Building Permit Application

Permit No.: **B19000497**

Building Address: 5042 Gaithers Chance Dr
 City: Dayton State: MD Zip Code: 21036
 Suite/Apt. #: _____ SDP/WP/BA #: GP-19-061
 Census Tract: _____ Subdivision: Gaithers Chance
 Section: _____ Area: _____ Lot: 6
 Tax Map: _____ Parcel: _____ Grid: _____
 Zoning: _____ Map Coordinates: _____ Lot Size: _____

Description of Work: New 2 story "Clifton Park II" FLV A, with 2 car side garage, 2 car side attached garage, morning room sitting area, suite 1st floor, 5th bedroom option, covered porch, finished lower level (office, media, exercise, wet bar, bathroom + powder room)
 Occupant or Tenant: _____

1 SECOND FLOOR PLAN
SCALE: 1/4" = 1'-0"

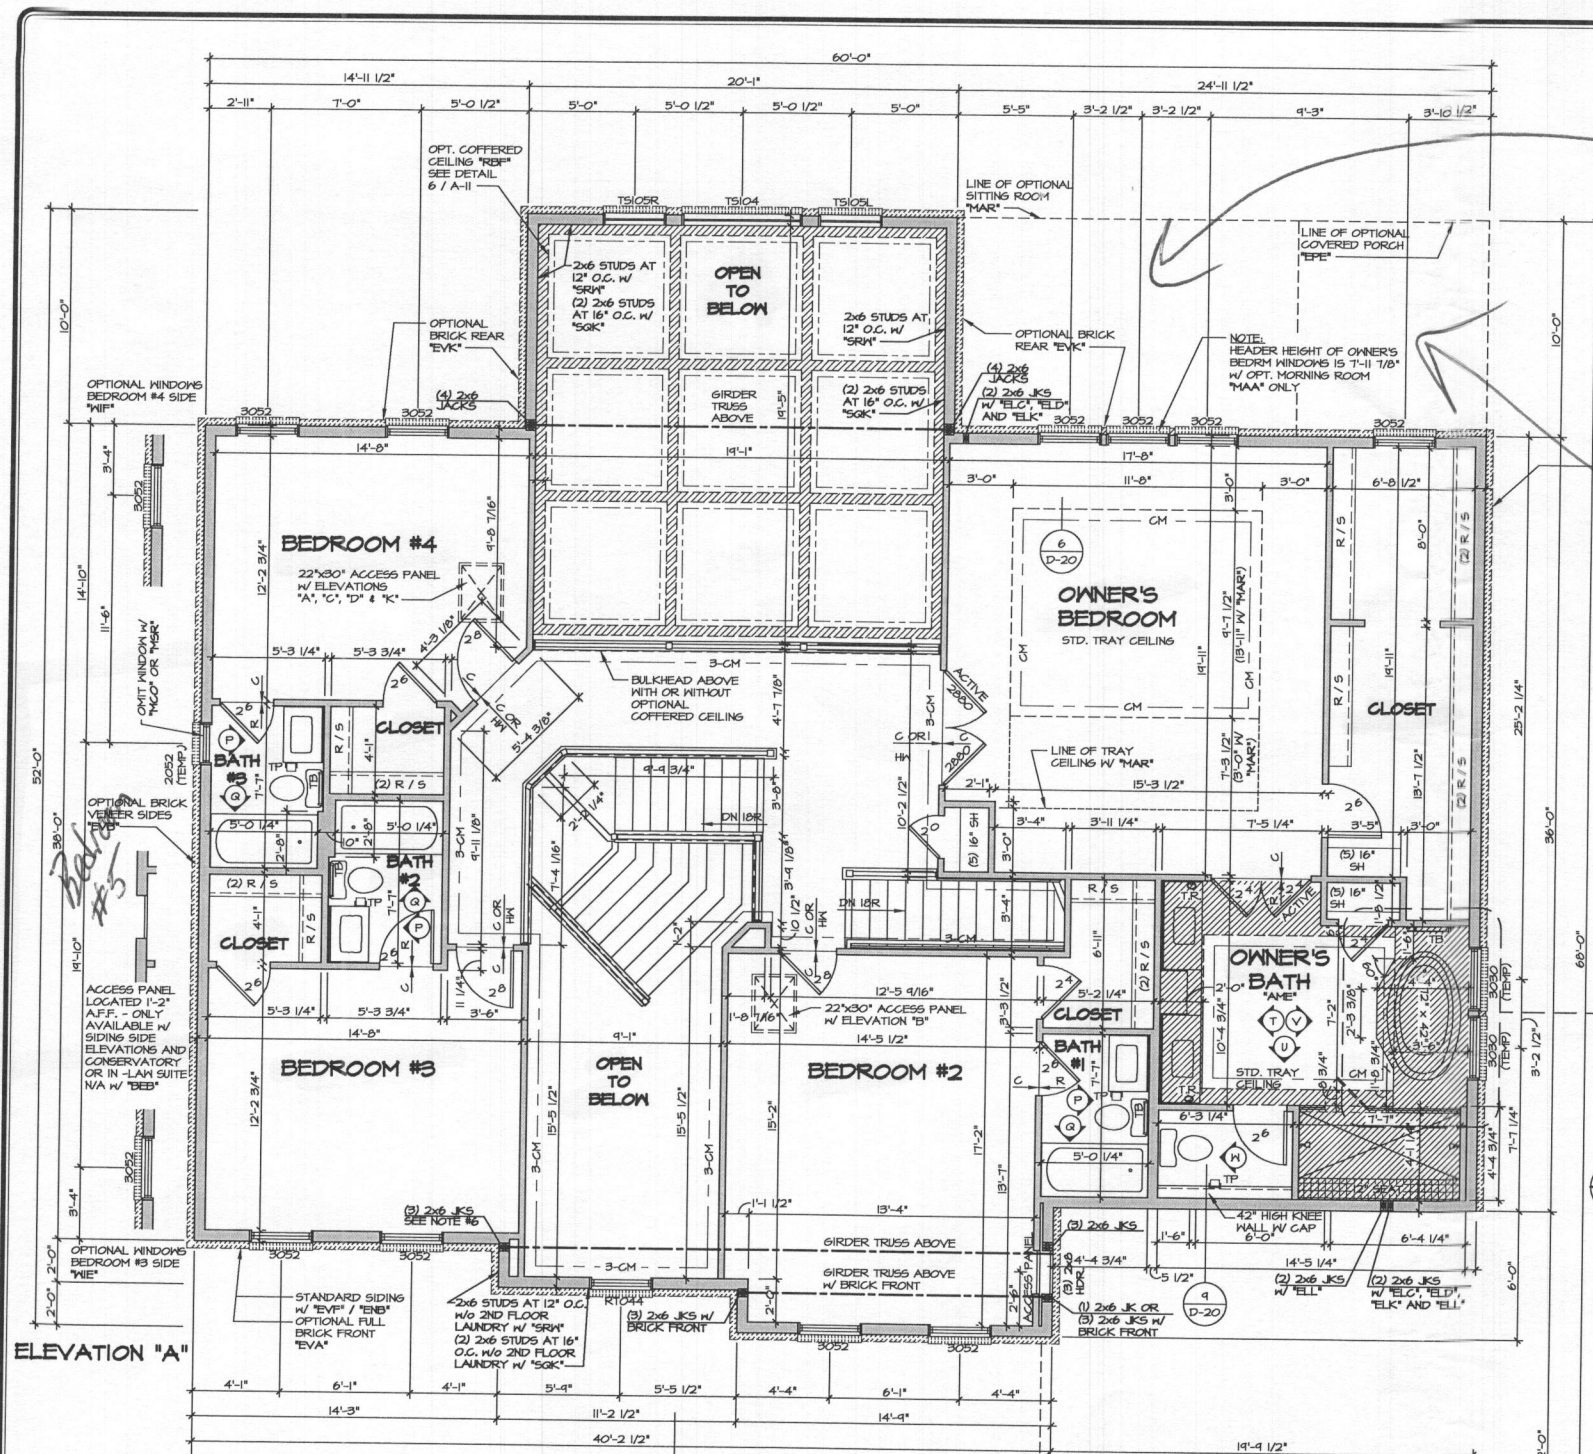
*5 Bedrooms
'OK' RD 3/15/2019
SEE SHEET A-10C*

MODEL	CLIFTON PARK II
SHEET NO.	A-10C
SET NO.	10300
VERSION	01
DRAWN BY	A.J.H.
DATE	12/21/12
OPTION	BEB VAN
DESCRIPTION	5TH BEDROOM SECOND FLOOR LAUNDRY
SHEET NO.	57

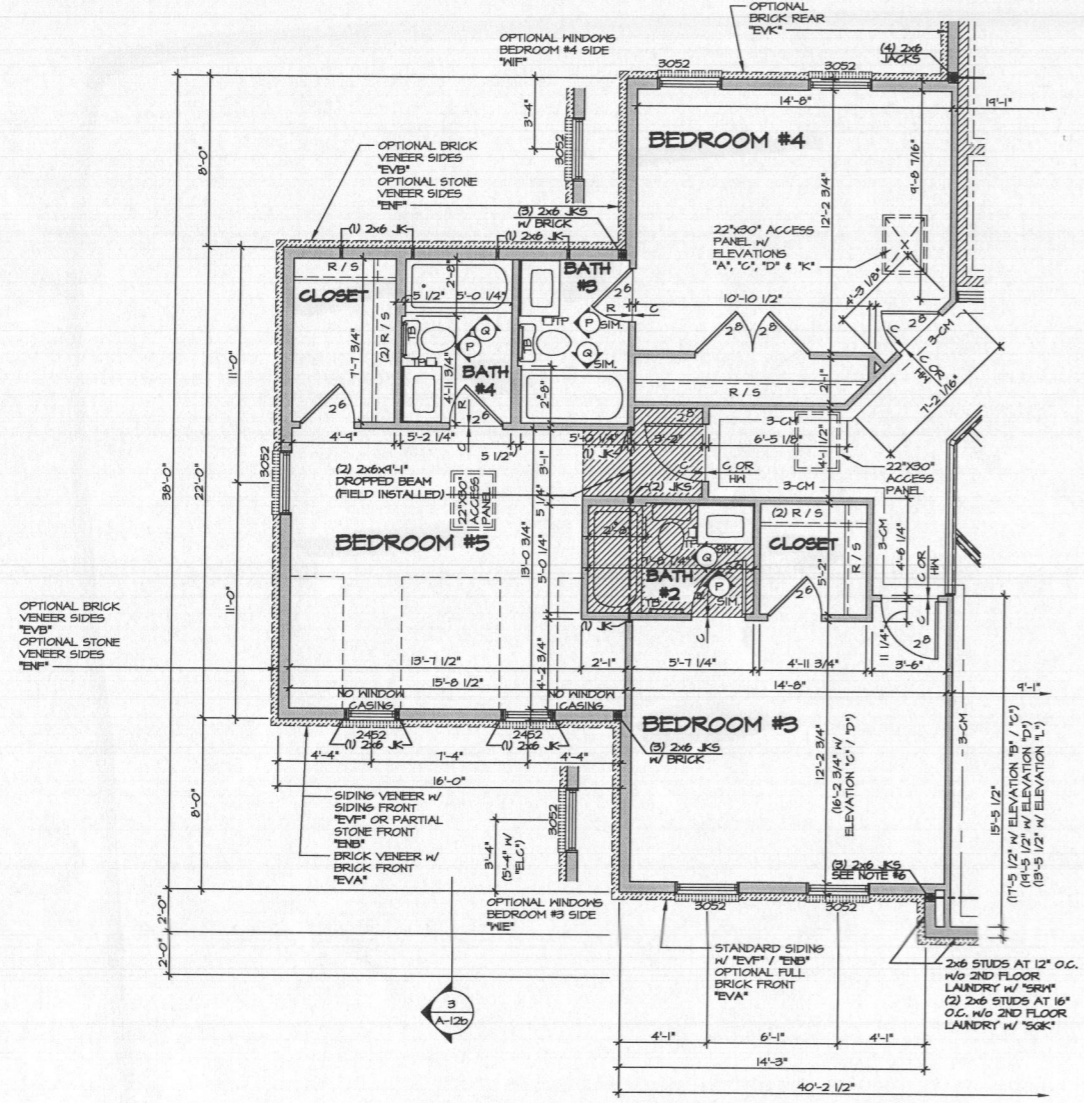
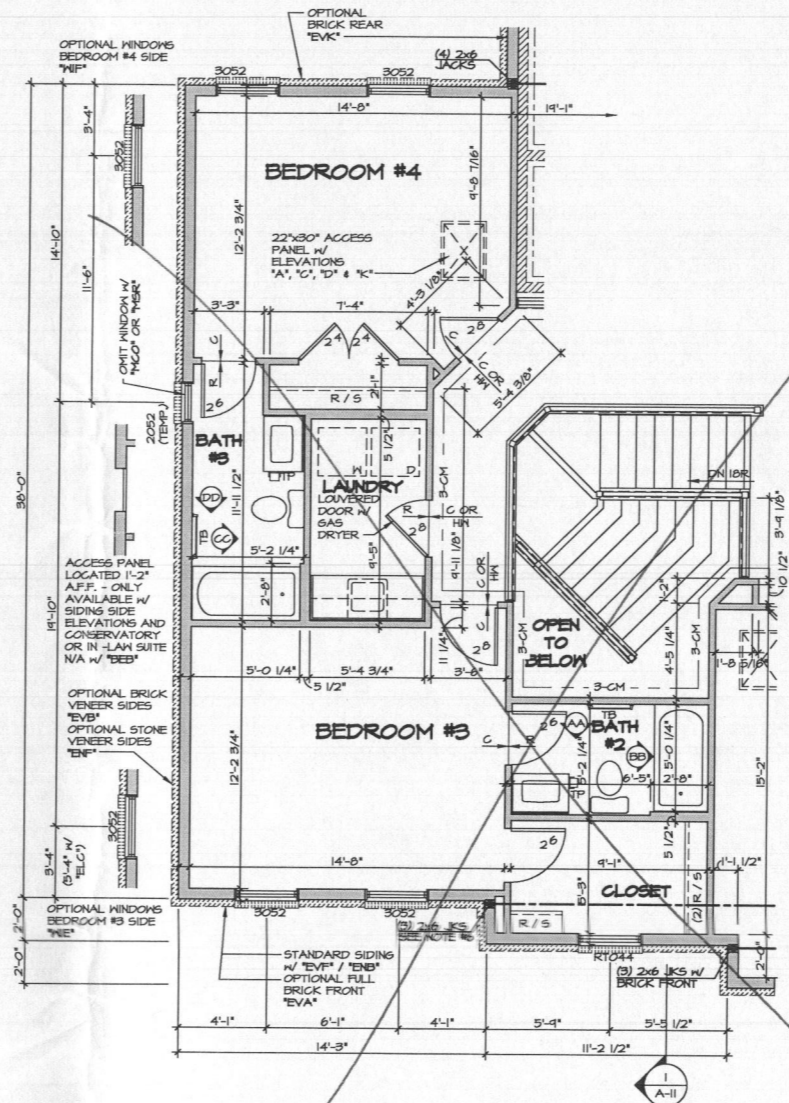
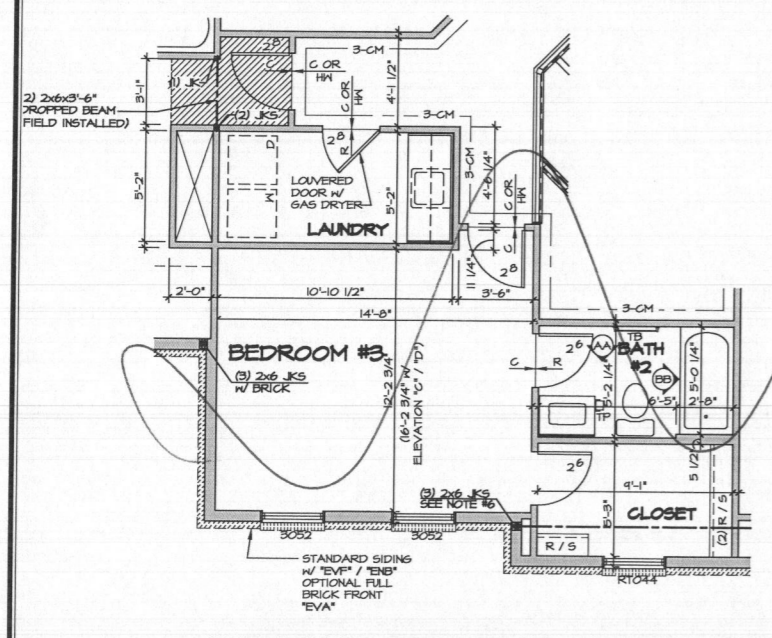
OK TAB
3/15/19
